Subject: **FCC Class II Permission Change Request for FCC ID: XMR2023SG560DWF**

This is to request a Class II Permission Change Request for FCC ID: XMR2023SG560DWF, originally granted on 2023/06/20.

The left is Old XO solution (No components at the marked area) and the right is New XO solution (Crystal oscillator symbol Y4101 added at the mark) .

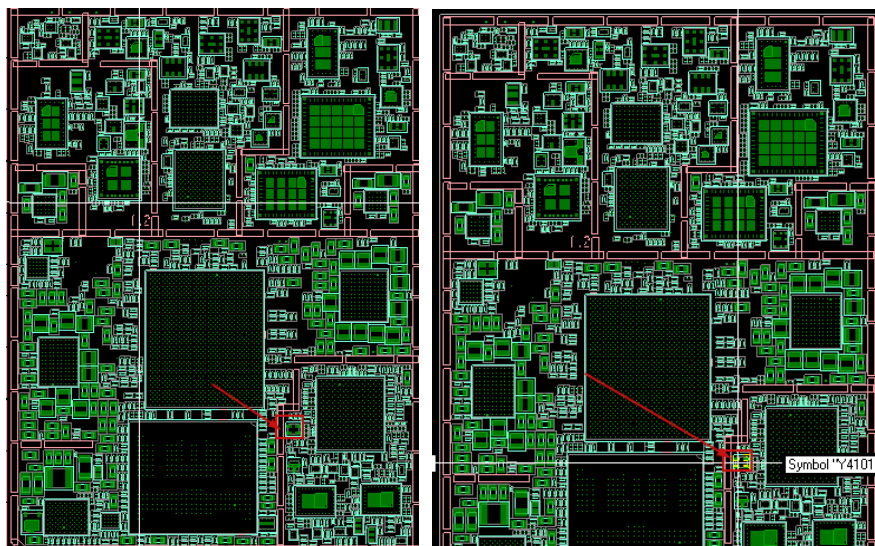
We have updated the clock scheme of the module WiFi unit, and the old clock scheme continues to provide the clock signal for the entire system except WiFi. The left figure shows the original clock scheme, and the right figure shows the updated clock scheme. After the update, the module is the same everywhere except for the difference in the clock scheme of WiFi. The new XO solution has no RF impact.
